Access Compliance Report Public Rights-of-Way (Curb Ramps)

Main Street: ROLLING_RIDGE Cross Street: SHEA_RIDGE Location: N

ADA ID: RPRK211019142831 Ramp Type: Type 4 - Parallel Initial Pass/Fail: Fail Overall Compliance: No Severity Score: 45

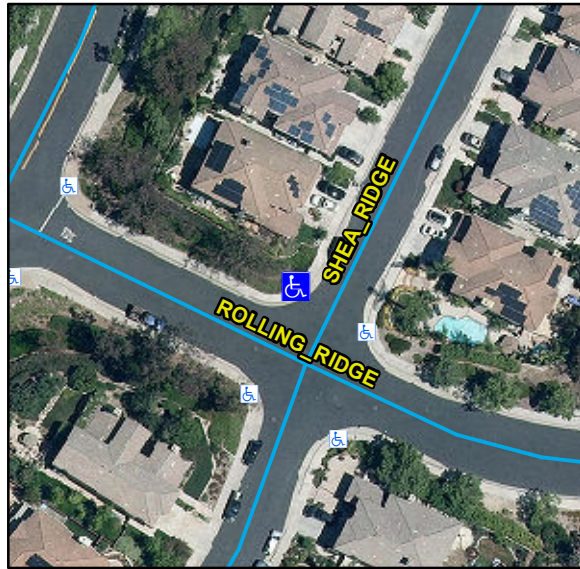
R204.3, R304.3.2, R304.5.3, STD 1115

Compliance	Description	Data	Compliance	Description	Data
N/A	Ramp Length LT (in)	125	N/A	Ramp Length RT (in)	116
Yes	Ramp Width LT (in)	54	Yes	Ramp Width RT (in)	54
No	Ramp Run Slope LT (%)	10	No	Ramp Run Slope RT (%)	8.4
No	Ramp Cross Slope LT (%)	12.1	No	Ramp Cross Slope RT (%)	13.1
N/A	Landing Present	N/A	N/A	DWS Provided	N/A
N/A	Landing Length (in)	N/A	N/A	DWS Contrast	N/A
N/A	Landing Width (in)	N/A	N/A	DWS Length (in)	N/A
N/A	Landing Run Slope (%)	N/A	N/A	DWS Full Width	N/A
N/A	Landing Cross Slope (%)	N/A		DWS Offset Type	N/A
N/A	Landing Movement Obstructed?	N/A	N/A	DWS Offset Left (in)	N/A
	Landing Movement Type	N/A	N/A	DWS Offset Right (in)	N/A
N/A	Landing Shared	N/A			
N/A	Clear Space	Yes			
N/A	Clear Space To Crosswalk (in)	N/A			
N/A	Marked Crosswalk 1	No	N/A	Marked Crosswalk 2	No
	Crossing 1 Direction	SW		Crossing 2 Direction	SE
	Marked Crosswalk 1 Width (in)	N/A		Marked Crosswalk 2 Width (in)	N/A

Remove & Replace Curb Ramp With Two New Directional Ramps or Equivalent.
